Identified Aboriginal cultural assets and values

Please provide any comments you may have on the identified Aboriginal cultural assets and values on the floodplain.

Draft Billabong Creek Floodplain Management Plan

Figure 2. Proposed Floodway Network for the Billabong Creek floodplain

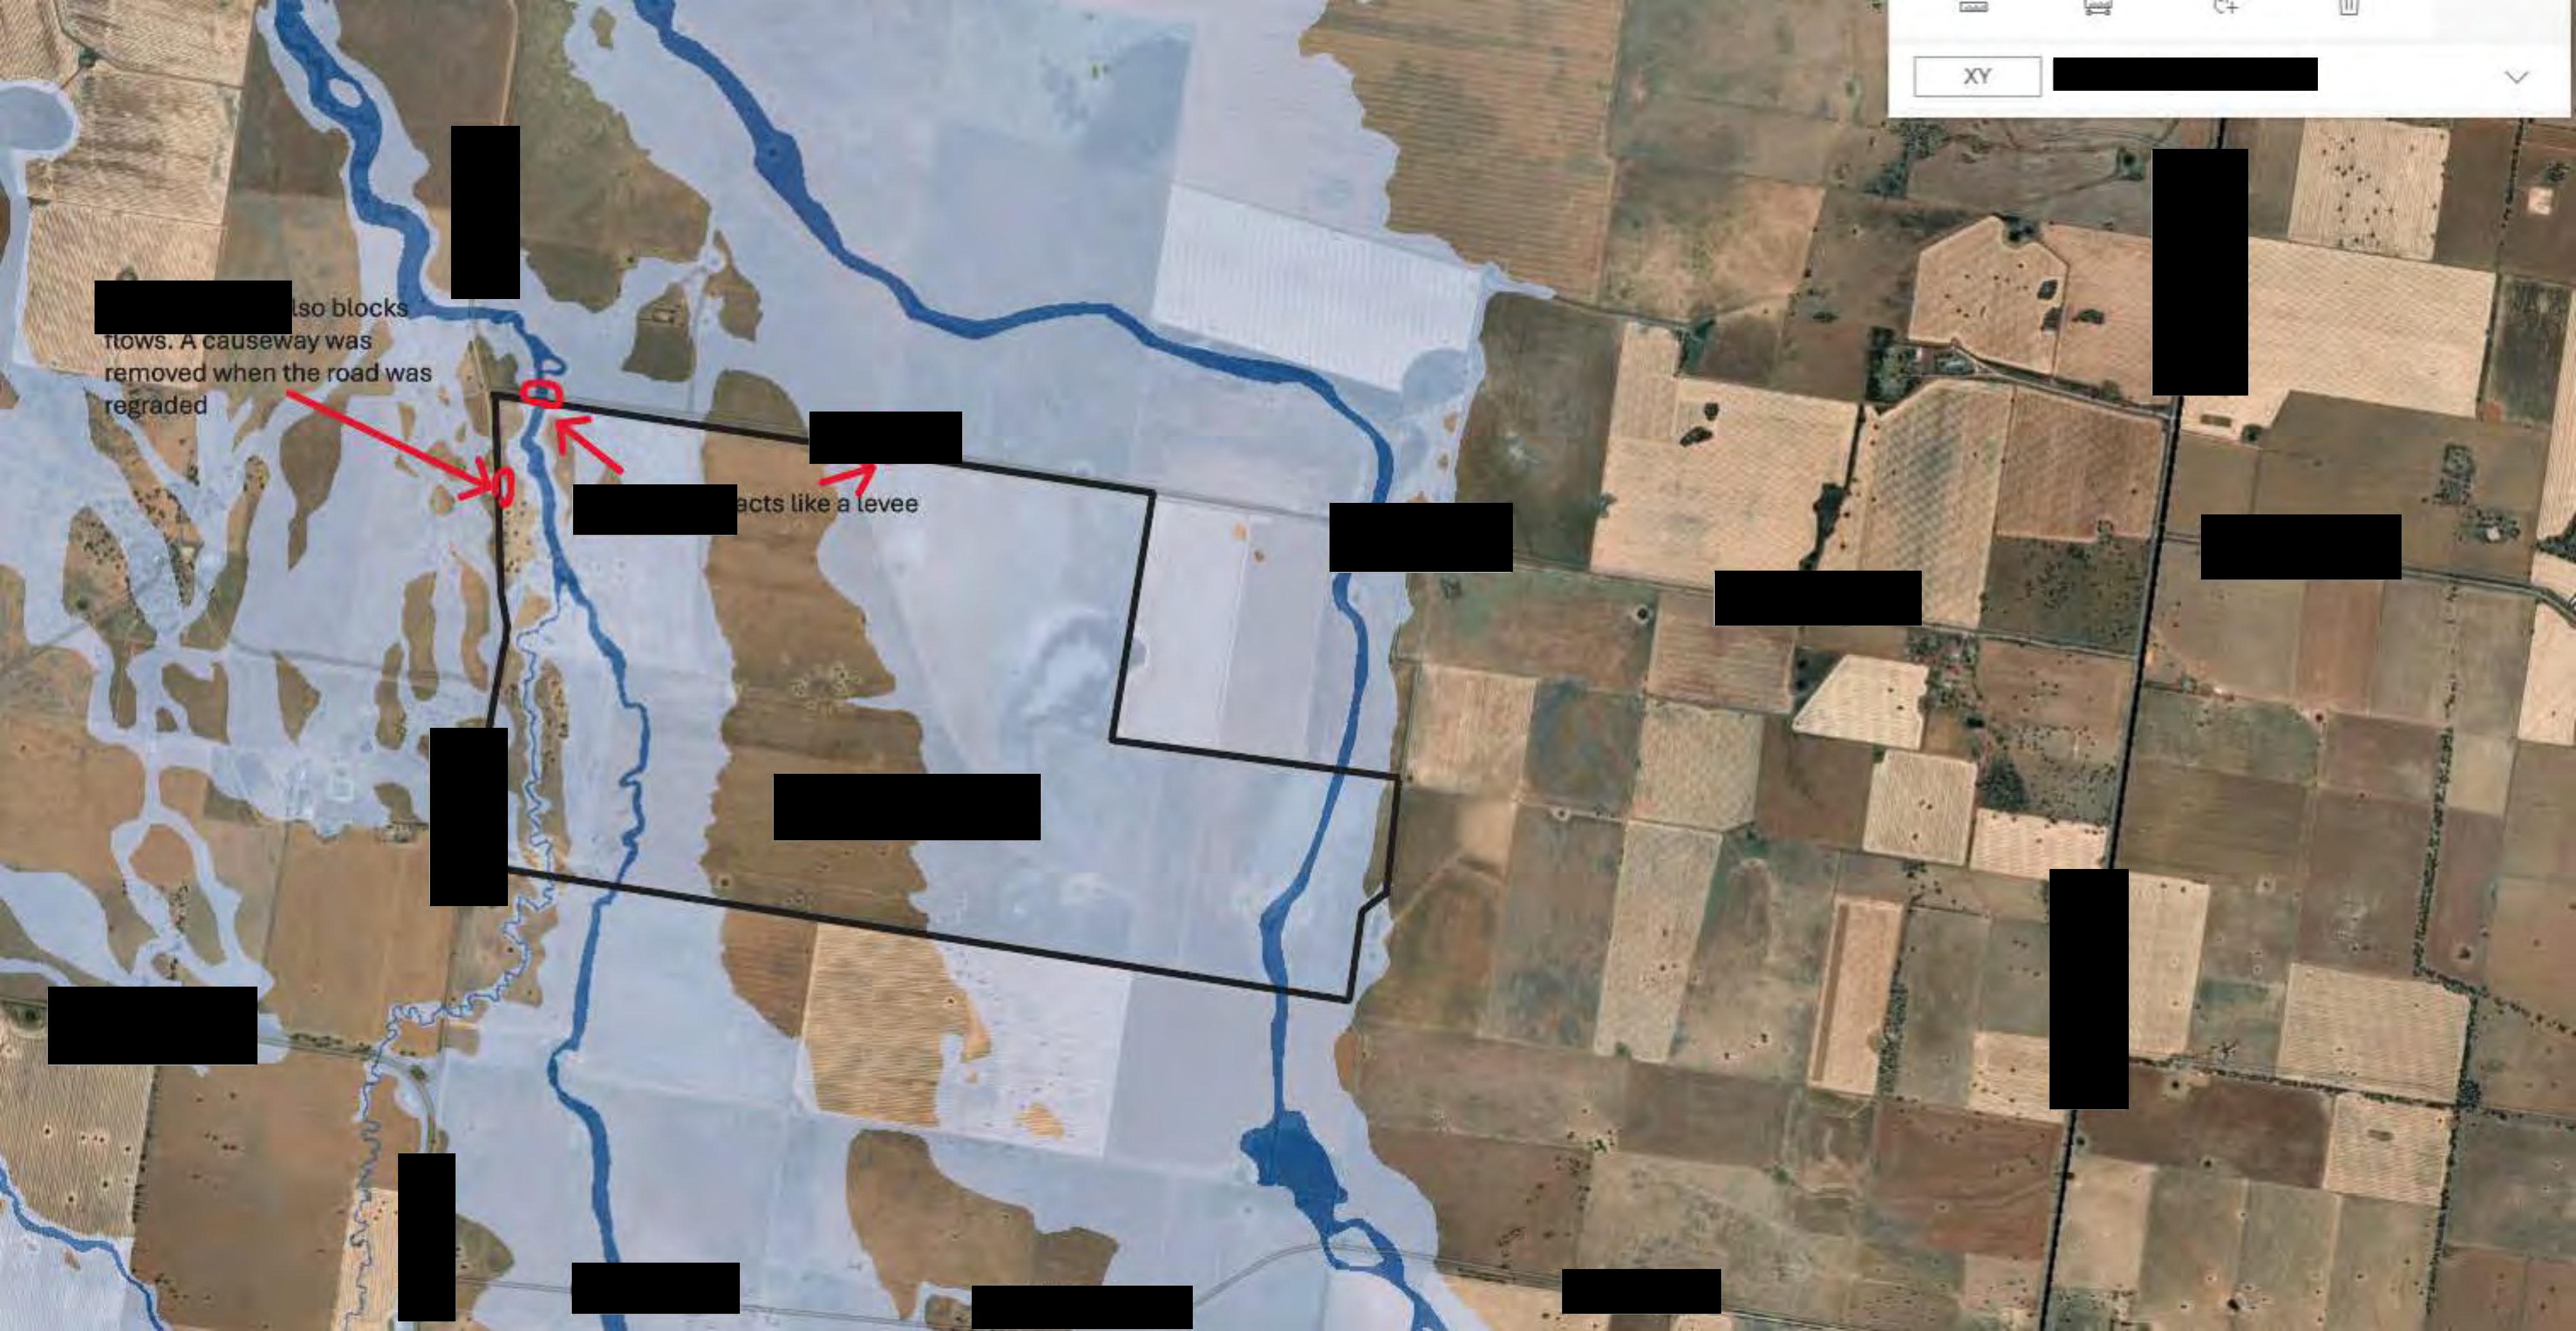
Swampy
area is ok

also blocks
flows. A causeway was
removed when the road was
regraded

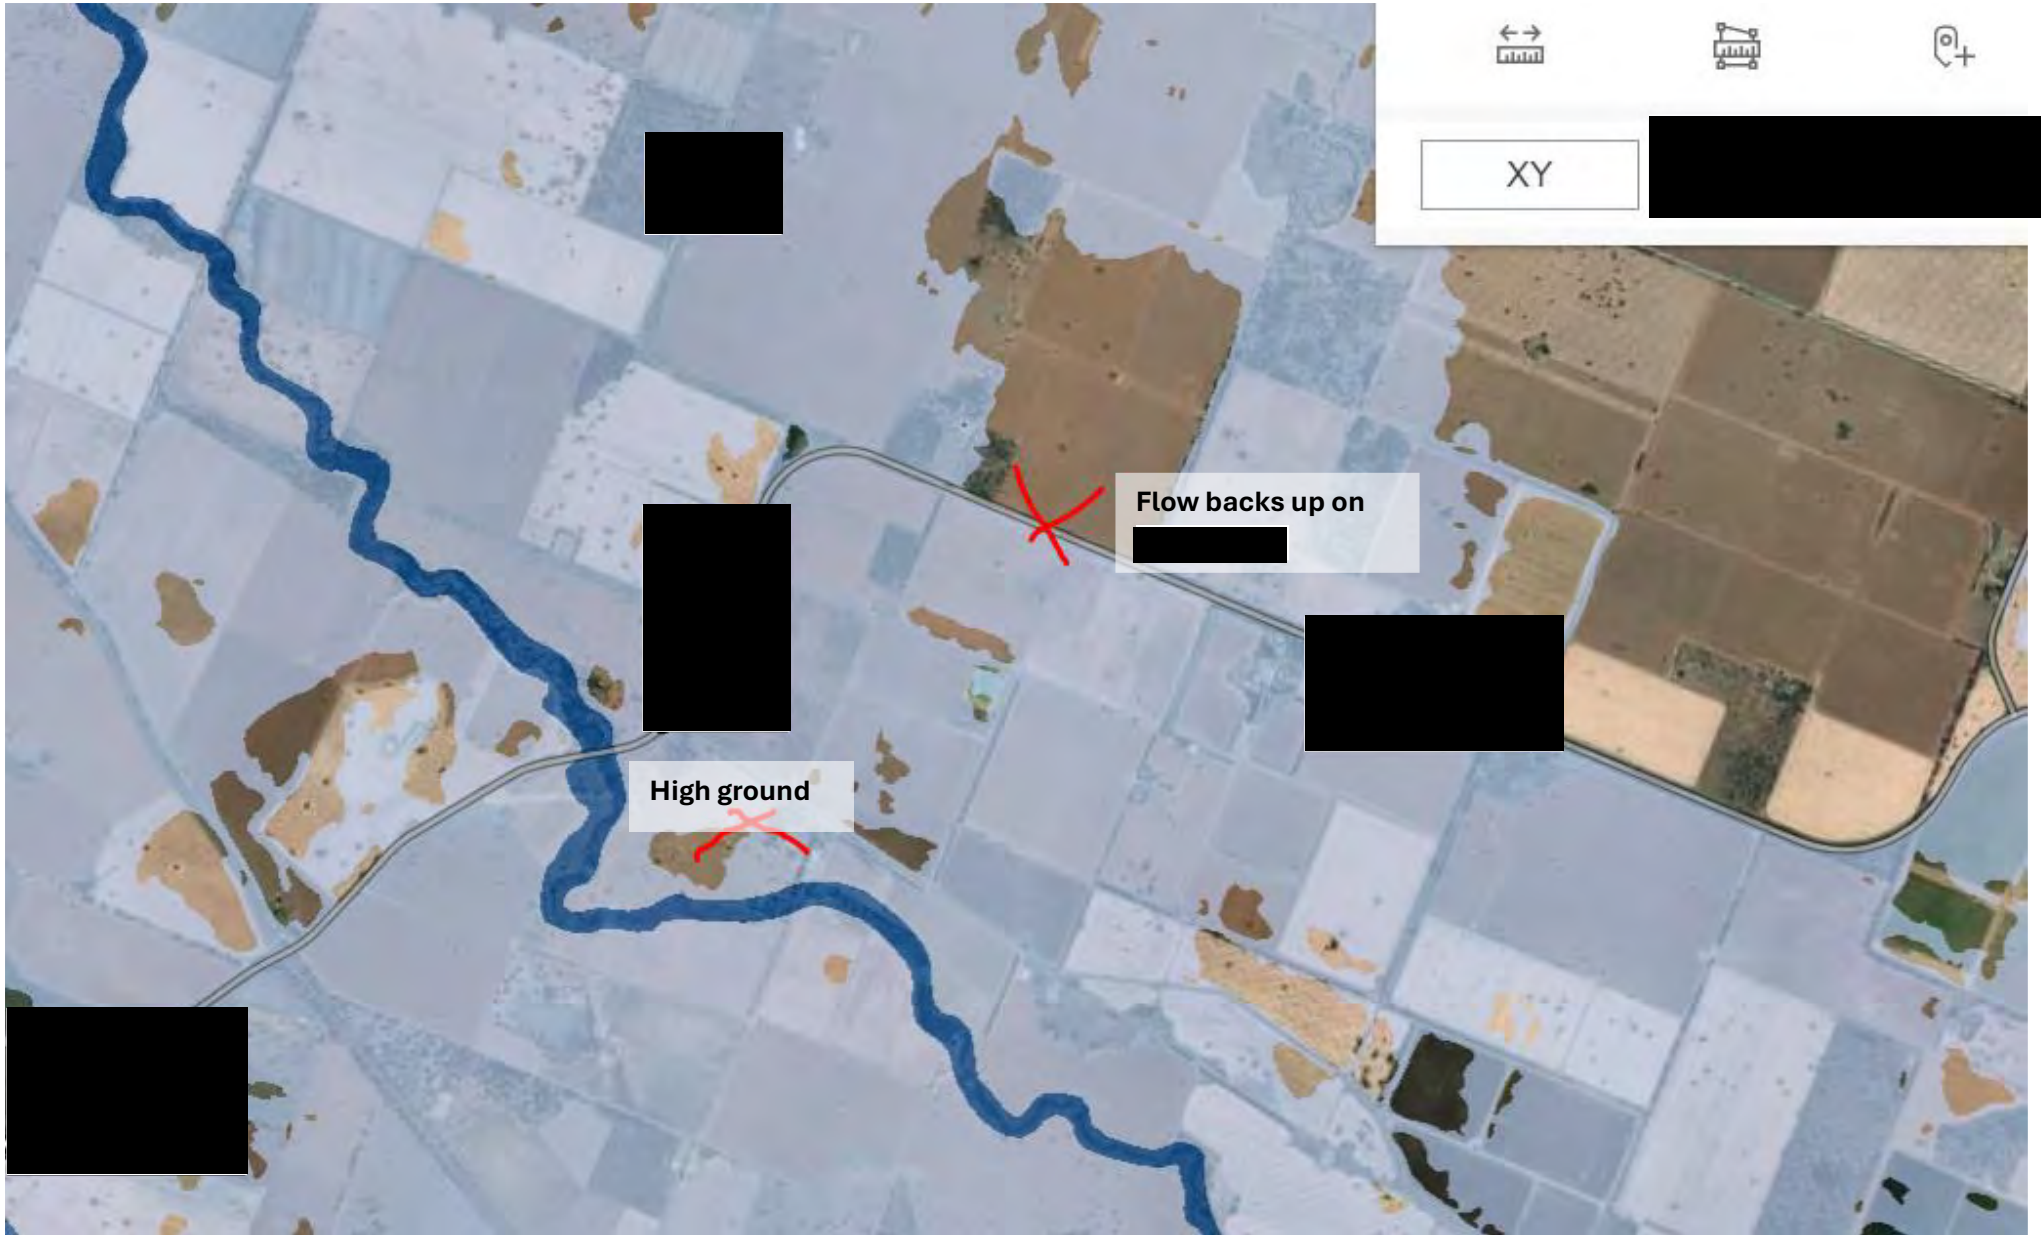
acts like a levee

Flow backs up on

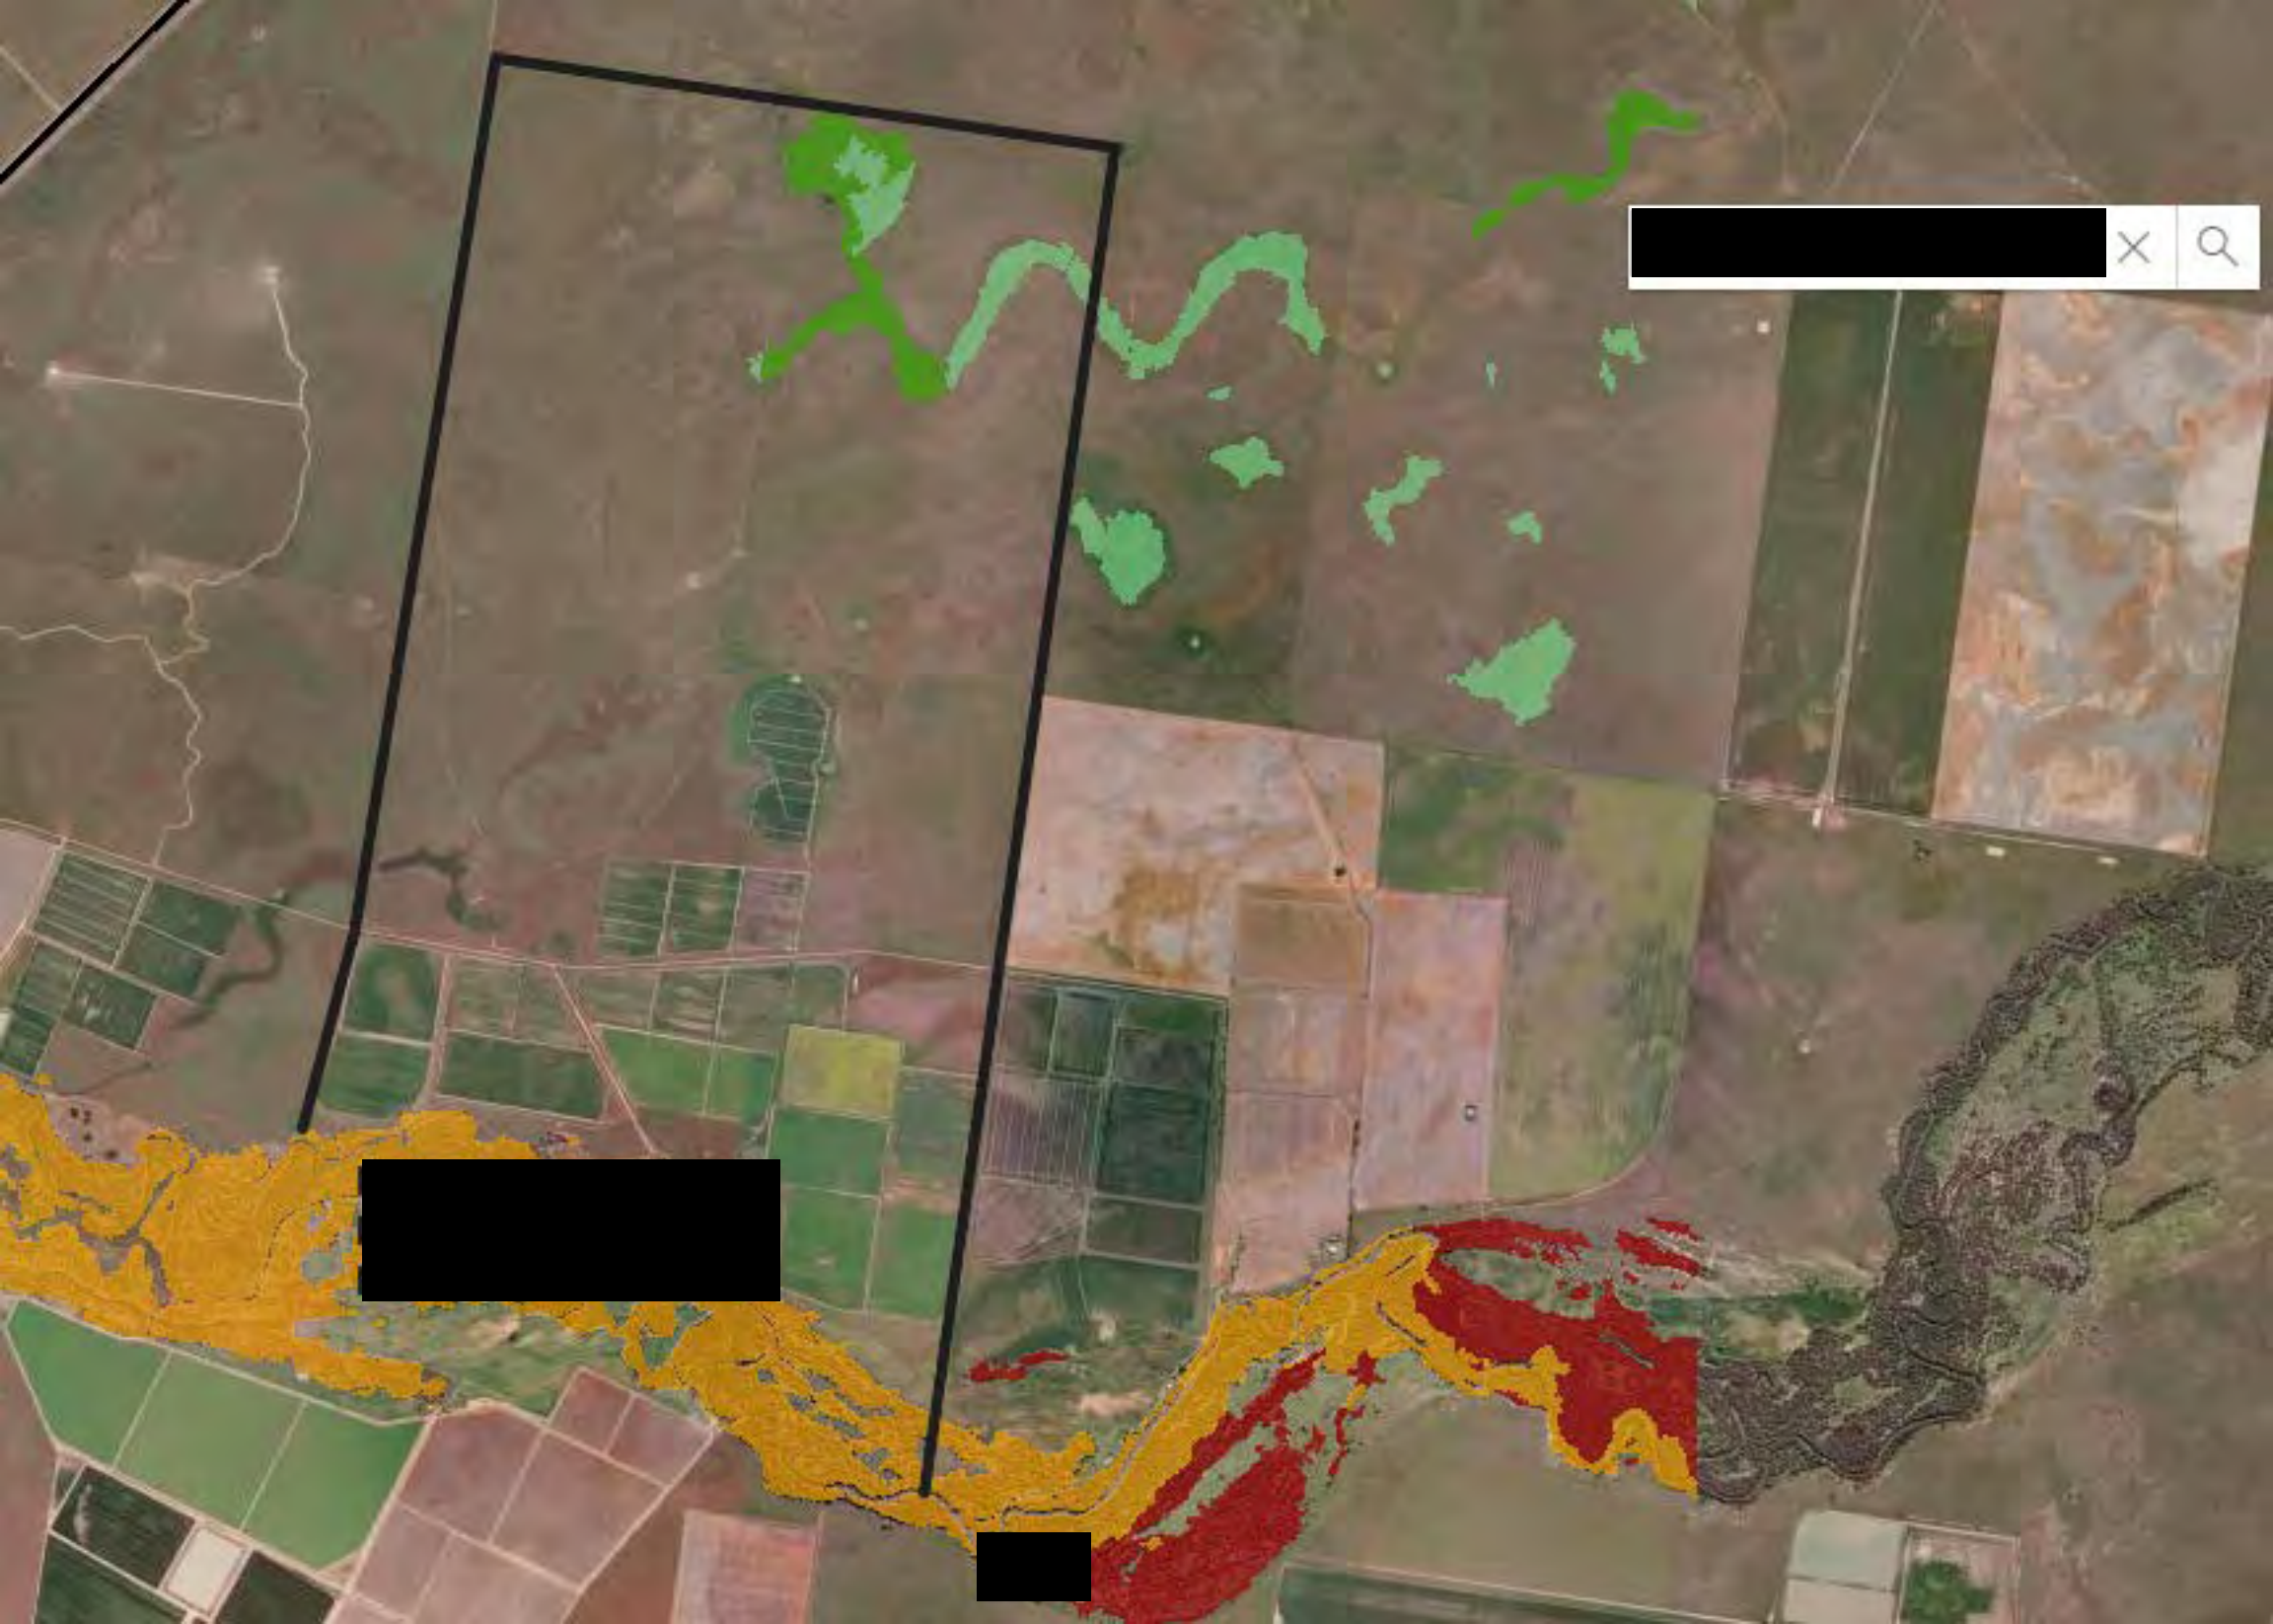
This is not flooding
from the creek. More
from localised rainfall.

Floodways & extent
generally ok near the
creek
